ADDENDUM No. 04

- A. Project Name: 2024 CAPITAL PROJECT PHASE 1.
- B. Building(s): MAIN BUILDING
- C. Owner: AFTON CENTRAL SCHOOL DISTRICT.
- D. Architect: HIGHLAND ASSOCIATES.
- E. Architect Project Number: 2025-005P.
- F. Construction Manager: SCHOOLHOUSE CONSTRUCTION SERVICES.
- G. Date of Addendum: DECEMBER 9, 2025.

**CONTRACTOR PRE-BID RFI FORM**

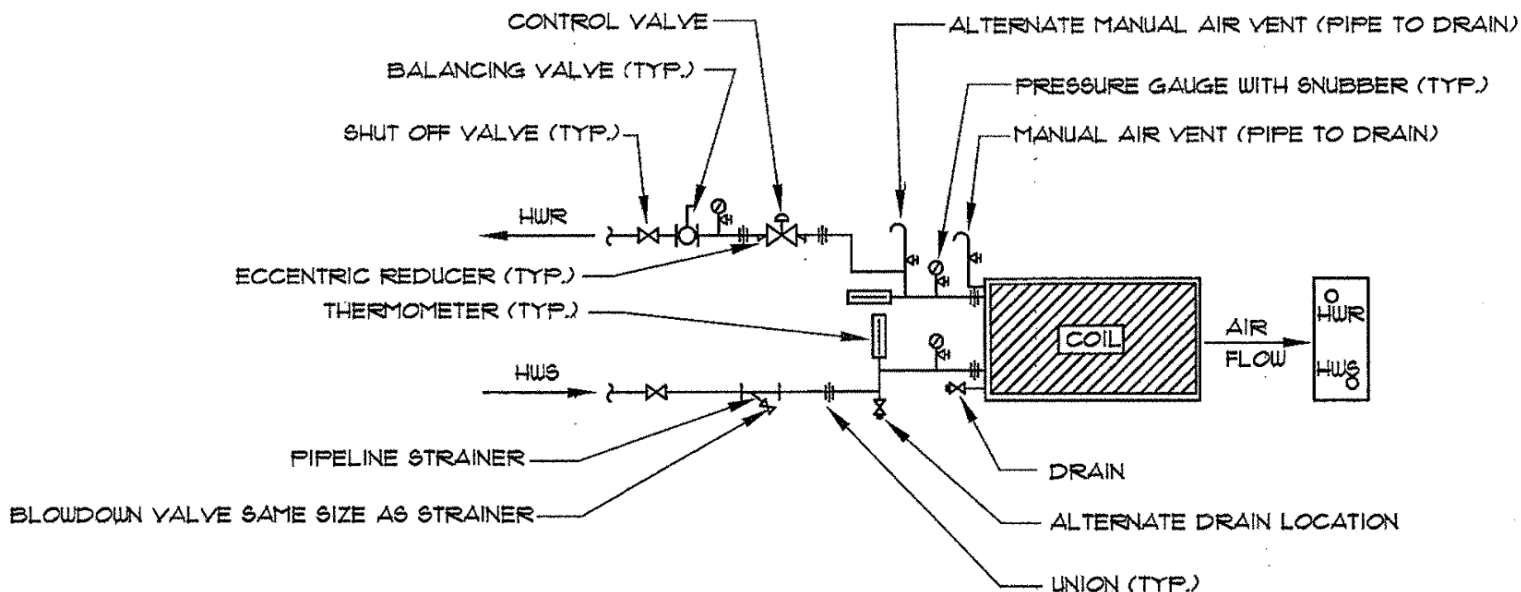
**REQUEST:** Please provide piping details for equipment piping.

**ANSWER:** See attached.
